Subject: Byron Generating Station Units 1 and 2
Braidwood Generating Station Units 1 and 2
Steam Generator Tube Vibration
NRC Docket Nos. 50-454, 50-455, 50-456,
and 50-457

FSAR Revisions to Implement 90/10

Feedwater Flow Split

BYRON/BRAIDWOOD STATIONS
FINAL SAFETY ANALYSIS REPORT
FIGURE 3.6-2
HIG- ENERGY DIAGRAM - MAIN FEEDWATER

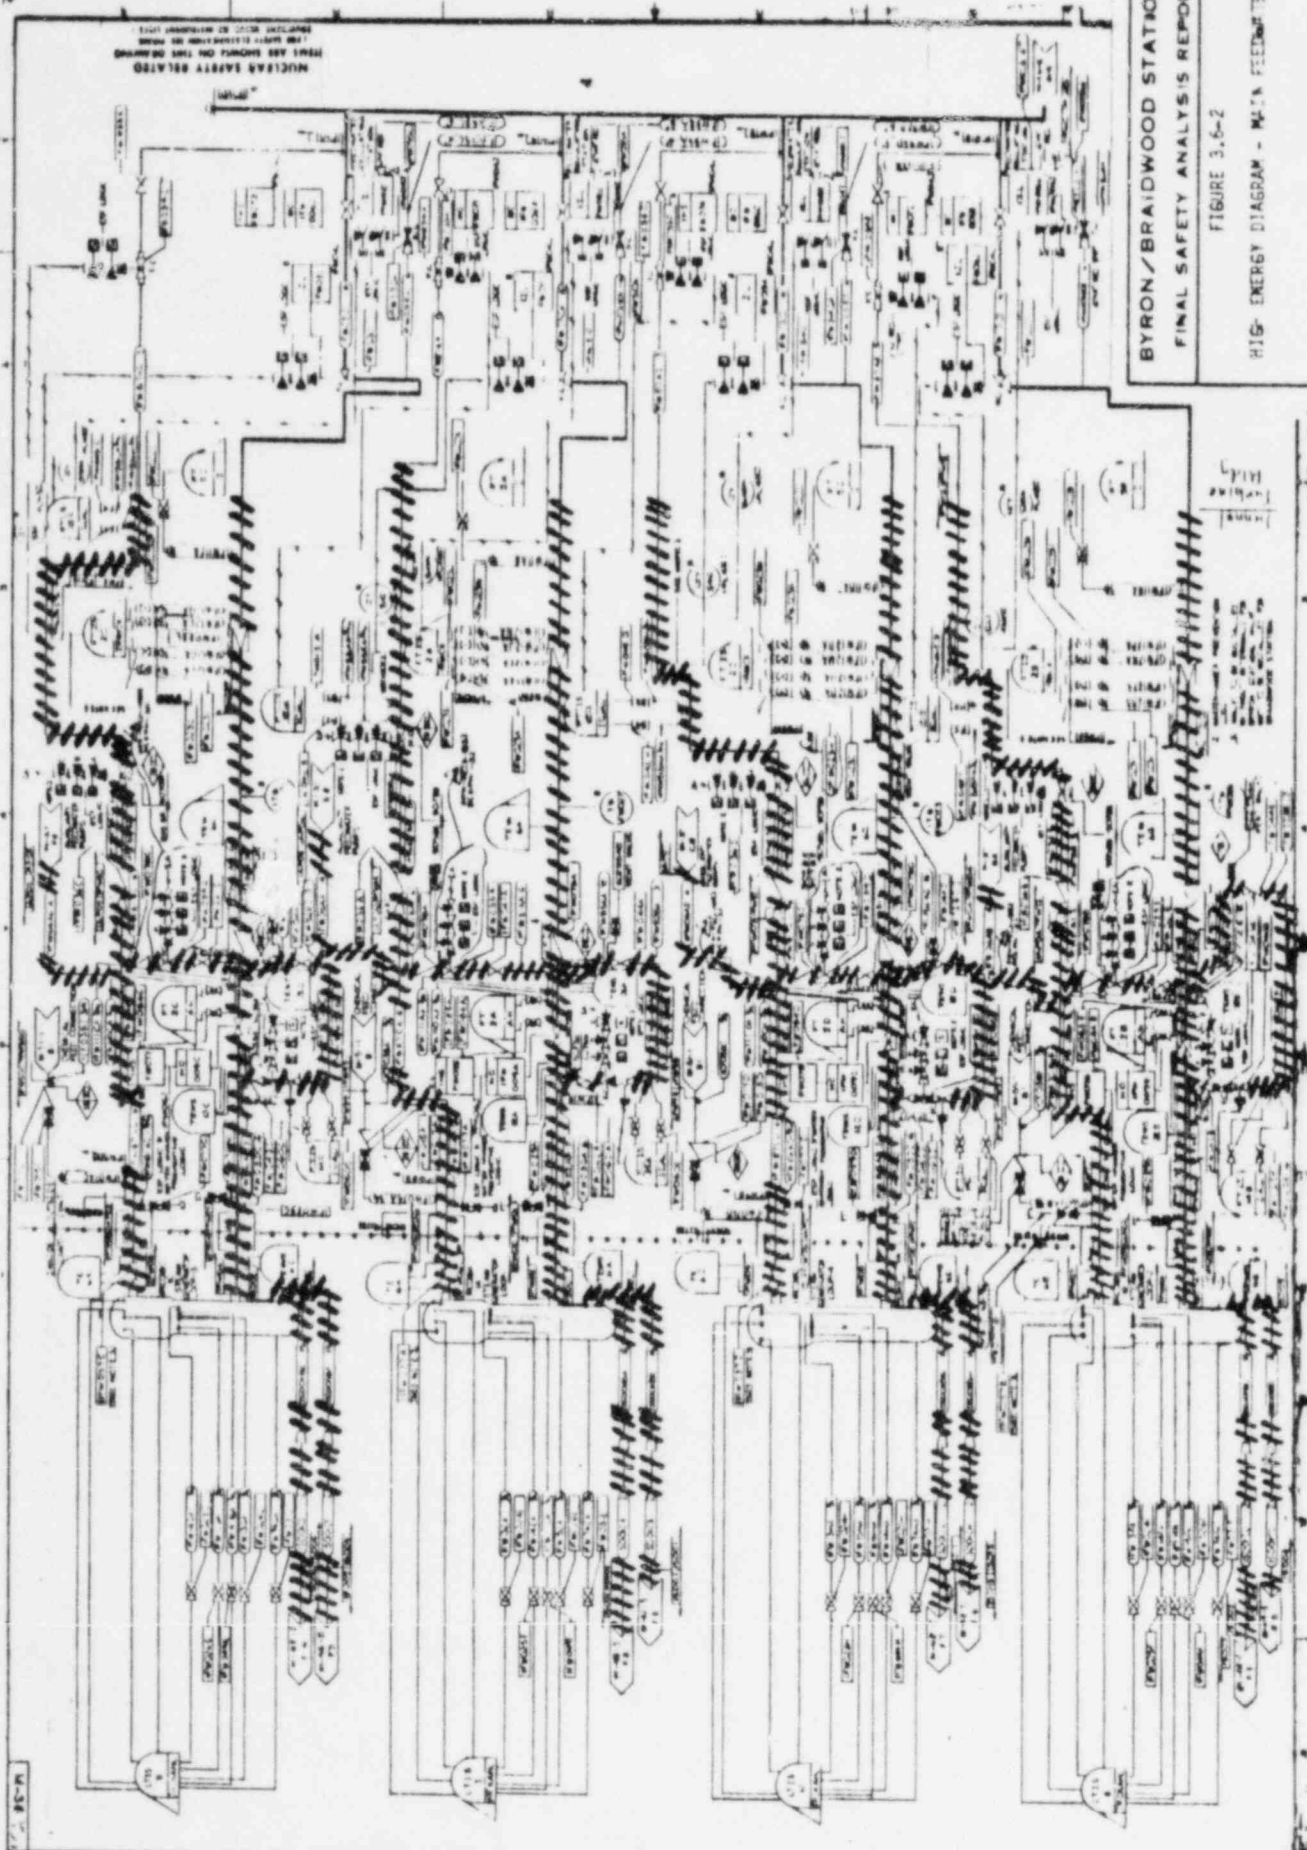
| 14. Figure 3.6-2 | Revisions |

Figure 4.4-9.
Reactor Coolant System Temperature
Percent Power Map

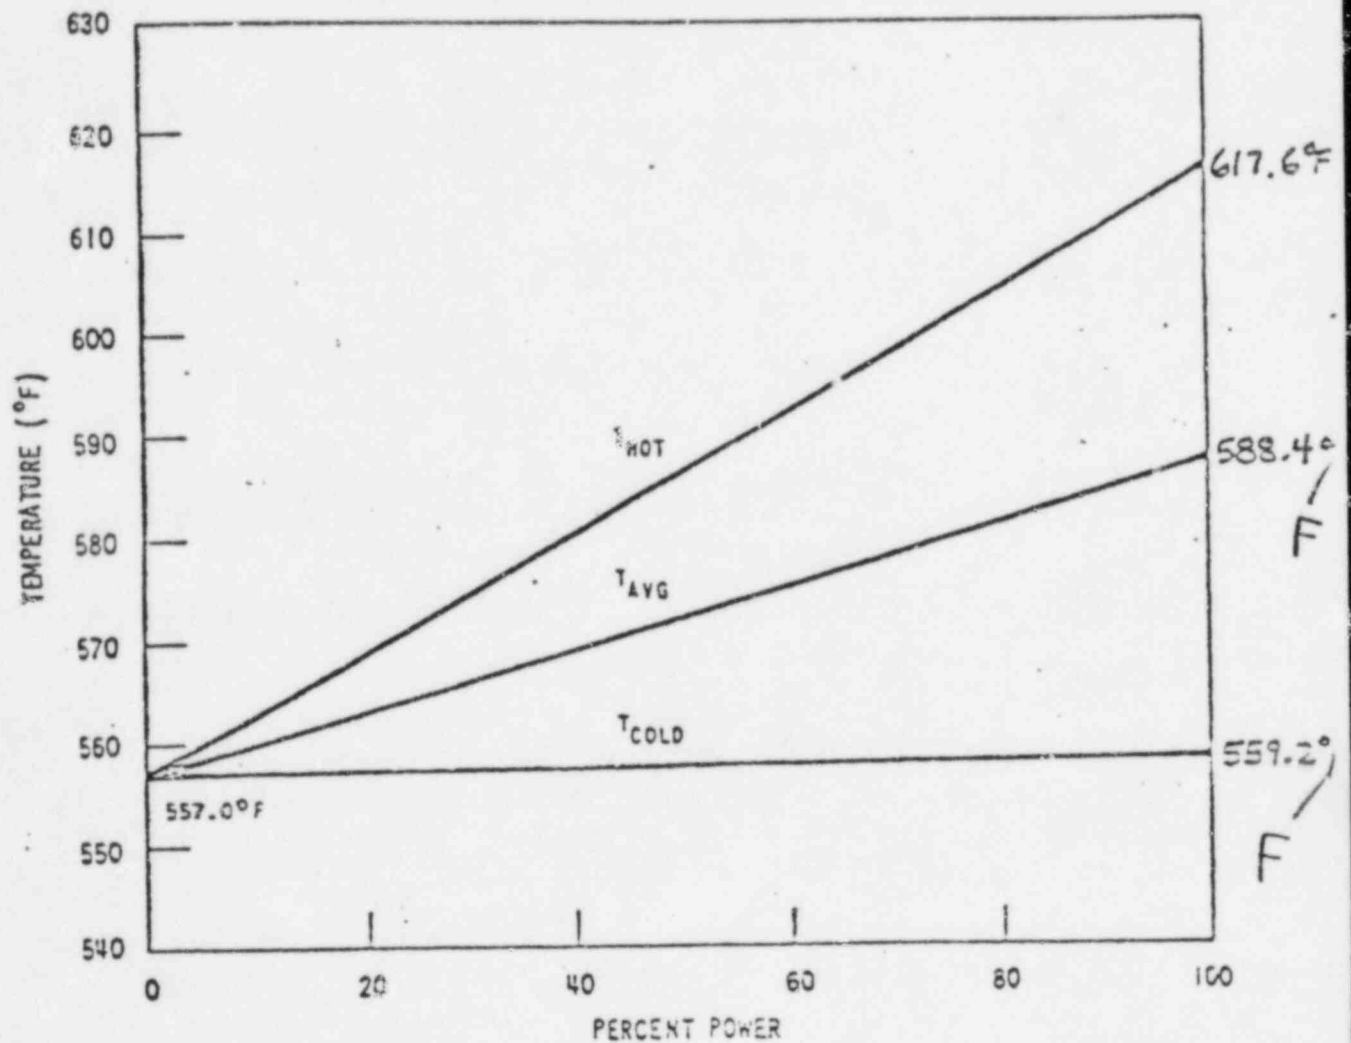
| 5. Figure 4.4-9 | Revisions |

BYRON/BRAIDWOOD STATIONS
FINAL SAFETY ANALYSIS REPORT
FIGURE 10.4-1
MAIN FEEDWATER SYSTEM
(SHEET 1 OF 3)

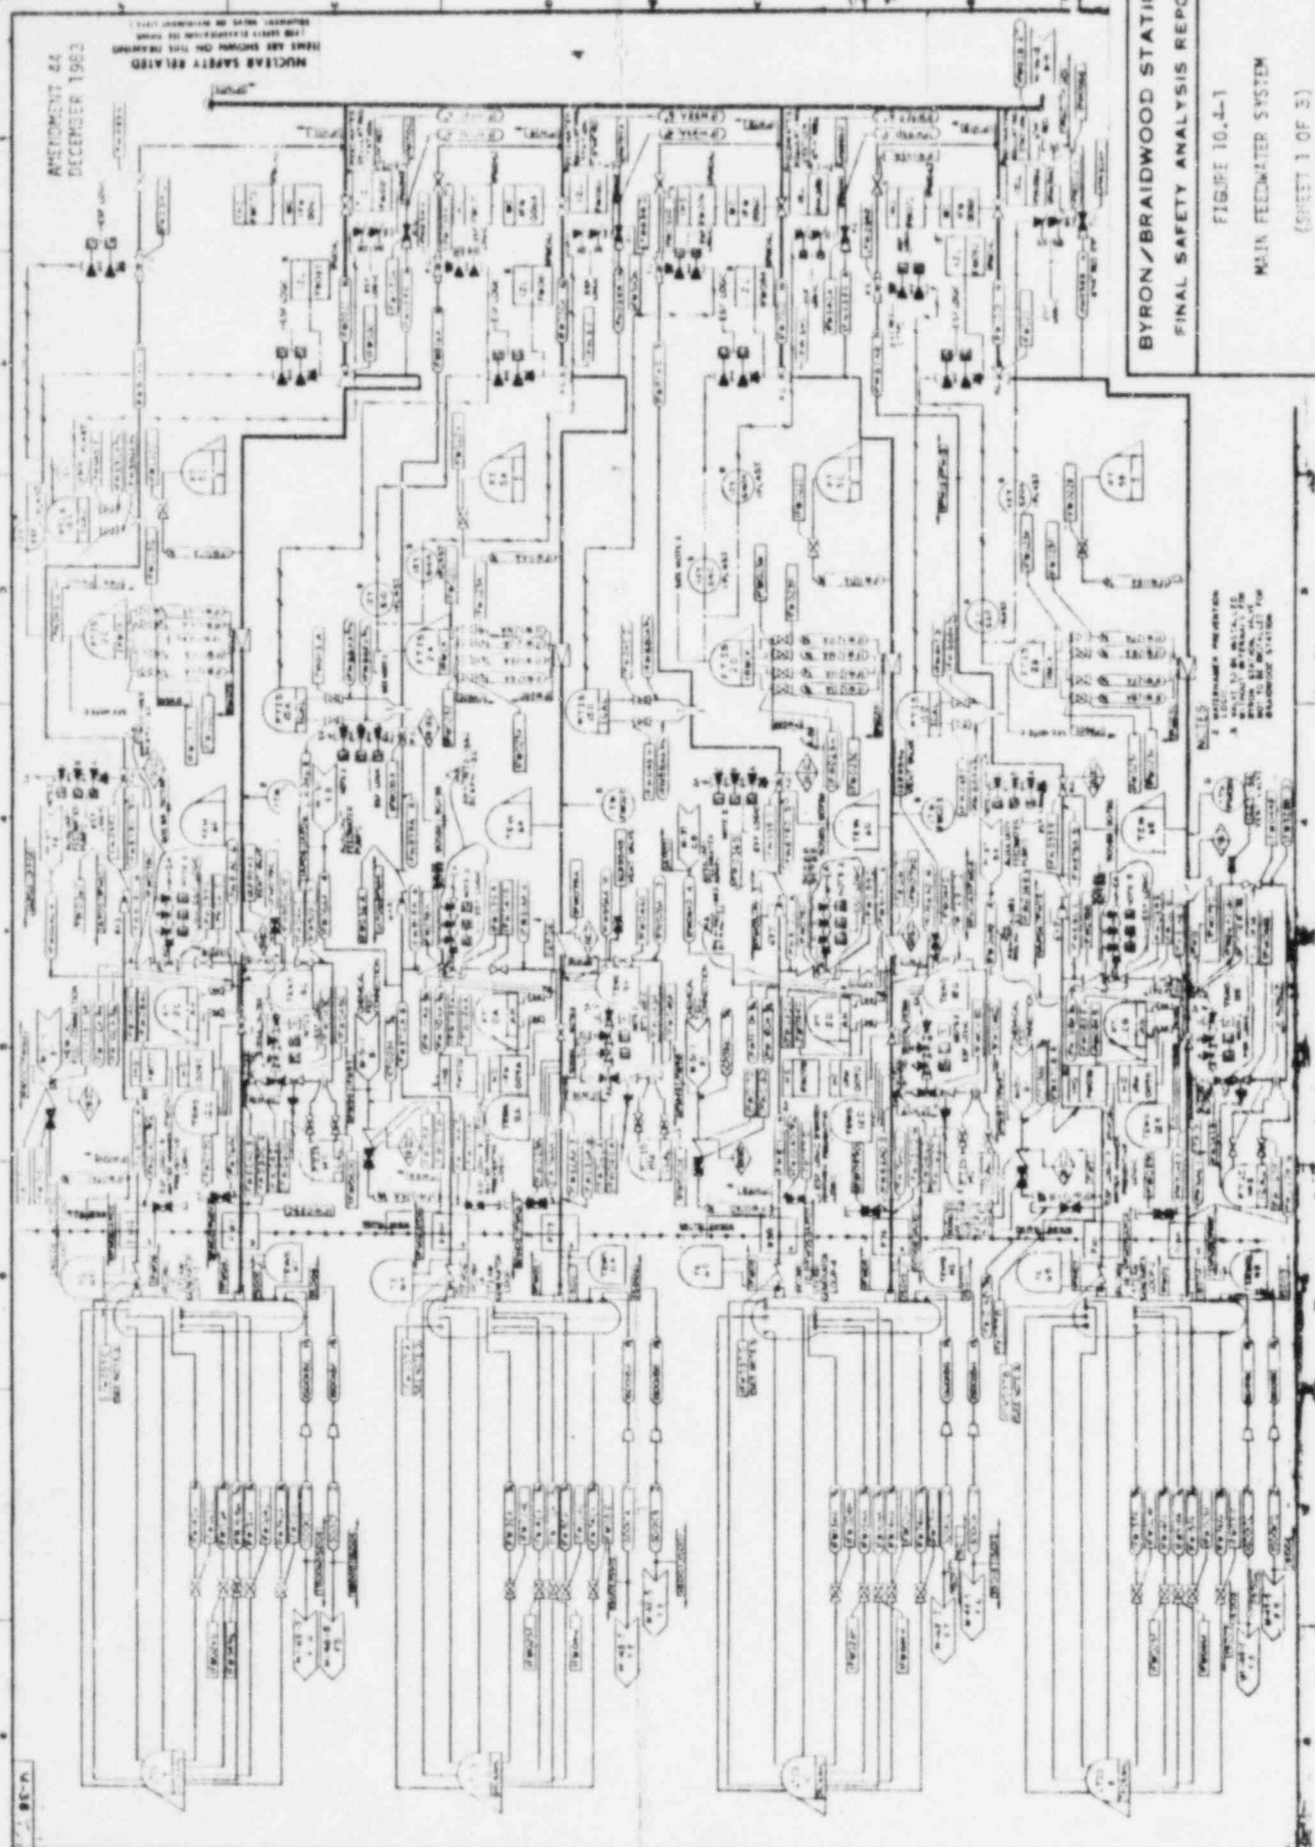
| 15. Figure 10.4-1 | Revisions |
